APPLICATION NO.	FILING DATE	FIRST NAMED INVENTOR	ATTORNEY DOCKET NO.	CONFIRMATION NO.
10/620,250	07/15/2003	Hiroshi Teramachi	10116/10	8901

Office Action Summary

DETAILED ACTION

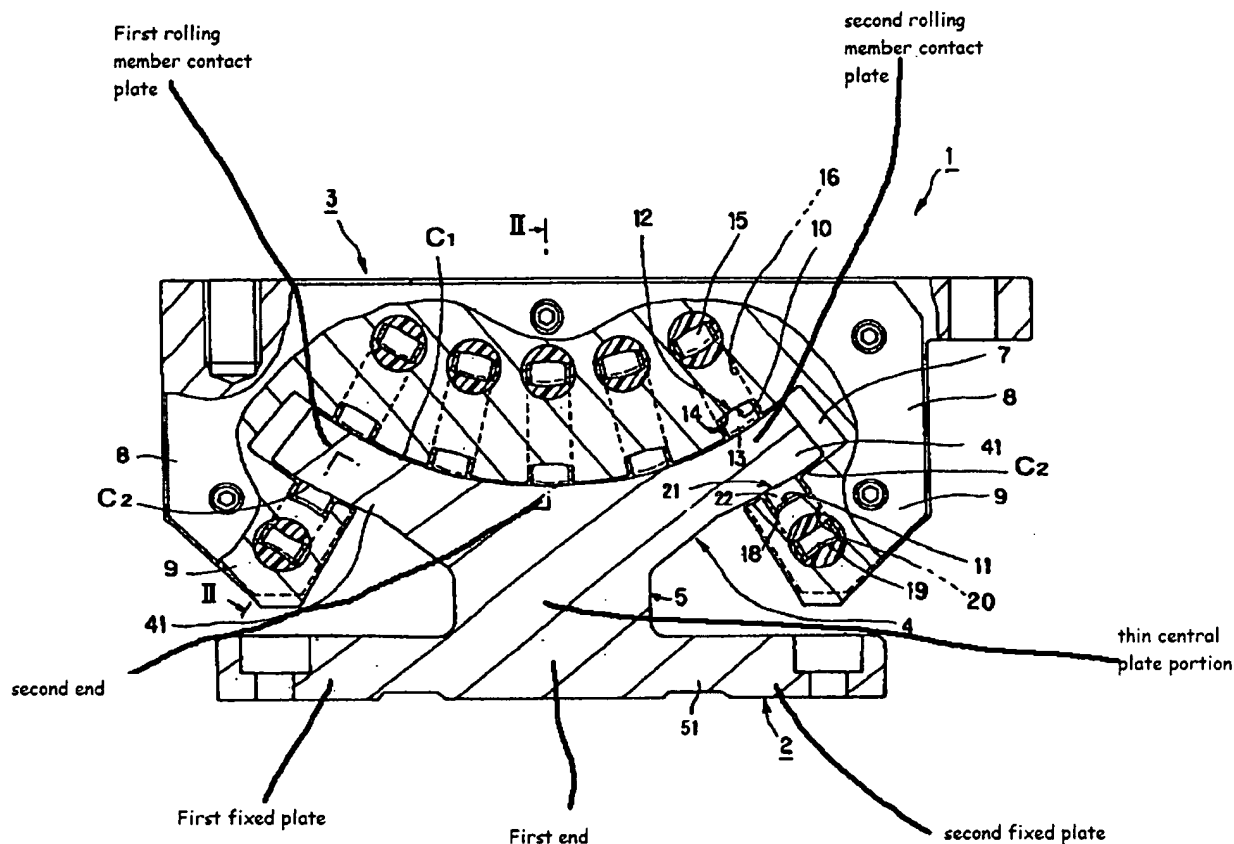
Claims 1 and 3-7 rejected under 35 U.S.C. 102(b) as being anticipated by Teramachi et al. (US Patent Number 6,312,158).

With respect to claim 1, Teramachi ('158) discloses a roller guide apparatus (1) comprising a track rail comprising a thin central plate portion with first and second ends, first and second rolling member contact plates projecting outwardly from said second end and first and second fixed plates projecting outwardly from said first end (see fig. below), and a movable block (3) having sets of endlessly circulating rolling member rows (5) that are in contact with the first and second rolling member contact plates of the track (column 2, lines 37-44). With respect to the elastically deformable claim limitation, as broadly recited, the rail of Teramachi ('158) is inherently "deformable" due to the physical properties of the material.

With respect to claim 3, Teramachi ('158) discloses the track rail to be an integral structure by drawing.

With respect to claim 4, Teramachi ('158) discloses a circular arc shape of the track rail (column 2, lines 29-33; figure 1, 41).

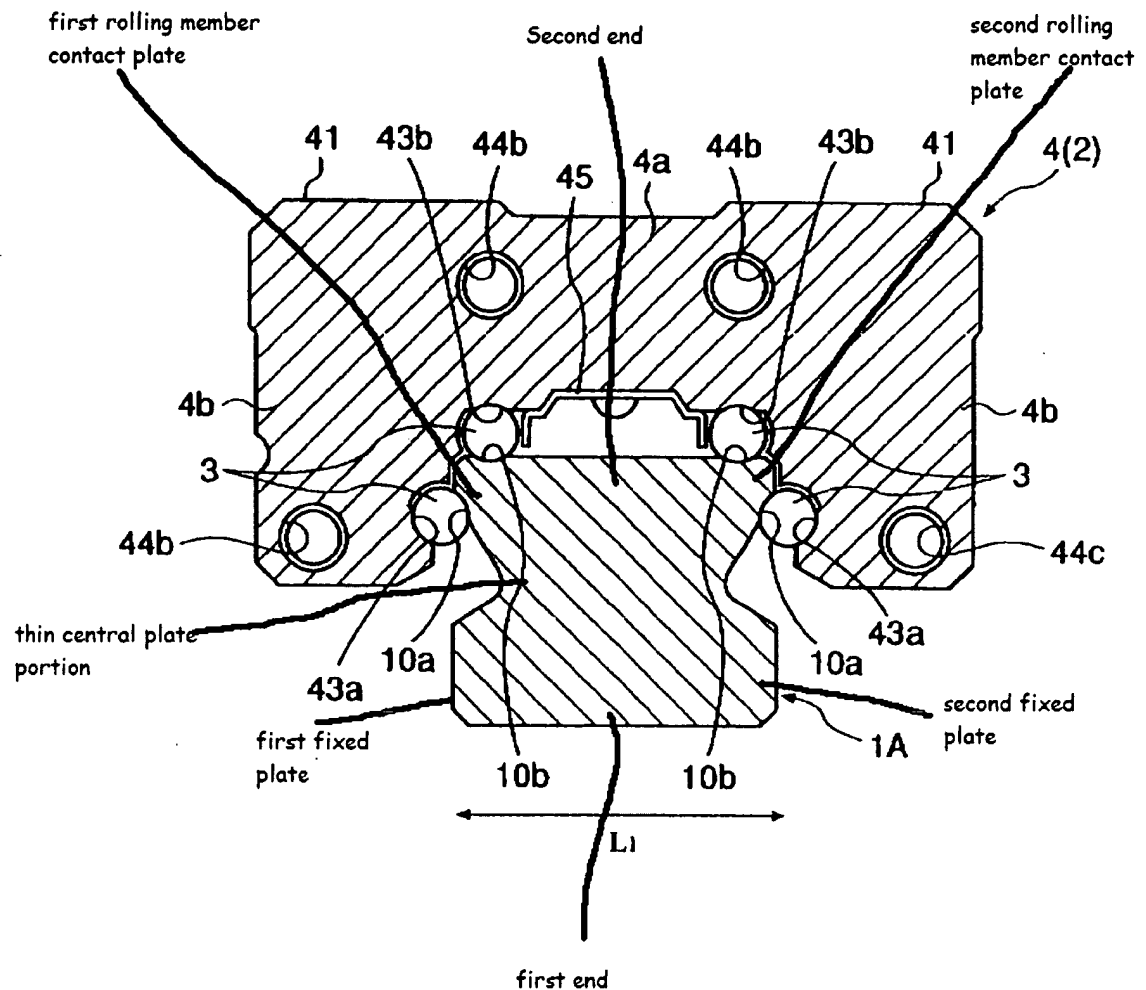
With respect to claim 5, Teramachi ('158) discloses the track rails as being orthogonal to each other allowing the movable structure to move in two orthogonal directions (column 4, lines 5-14, figure 7).

With respect to claim 6, Teramachi ('158) discloses the track rail comprising a rectilinear rail. (column 5, lines 29-33).

With respect to claim 7, Teramachi ('158) discloses the track rail comprising a curvilinear rail (column 5, lines 29-33).
